#### GOVERNMENT OF SAMOA MINISTRY OF WORKS, TRANSPORT & INFRASTRUCTURE

20 December 2019

## **Request for Additional works for the Friendship Park**

# Attachment 2: Harbour light photo

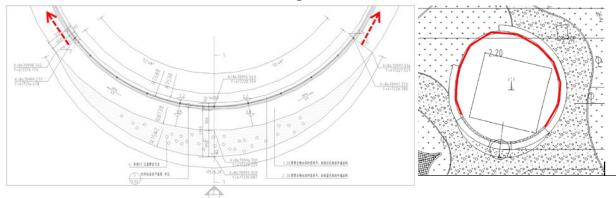
responsible authority is unable to carry out renovations to the harbour light before the park is opened. The harbour light is a key infrastructure in the park and if not renovated will be an eye sore when the park is officially open. We kindly request including minor repair works to the harbour light as part of the scope of works for Friendship Park project. Minor works include repainting the harbour light, replacing corroded railing, and repair the small building. Please refer to photos in Attachment 2.

Harbour light need minor repair works e.g. repainting.

Attachment 3: Extend fence around harbour light

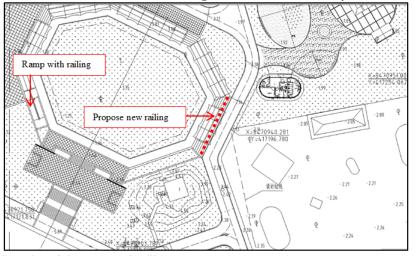
The harbour light at Eleele Fou is crucial to the safe navigation of sea vessels into the Apia Harbour and as a matter of security, it is off limits to the general public and particularly children that will be using the "Children's playground" next to the harbour light. We therefore request extending the proposed fence with a gate around the harbour light to control and restrict access into the harbour light area for safety and security of sea navigations. Please refer to attachment 3.

Proposed fence to extend around the harbour light.
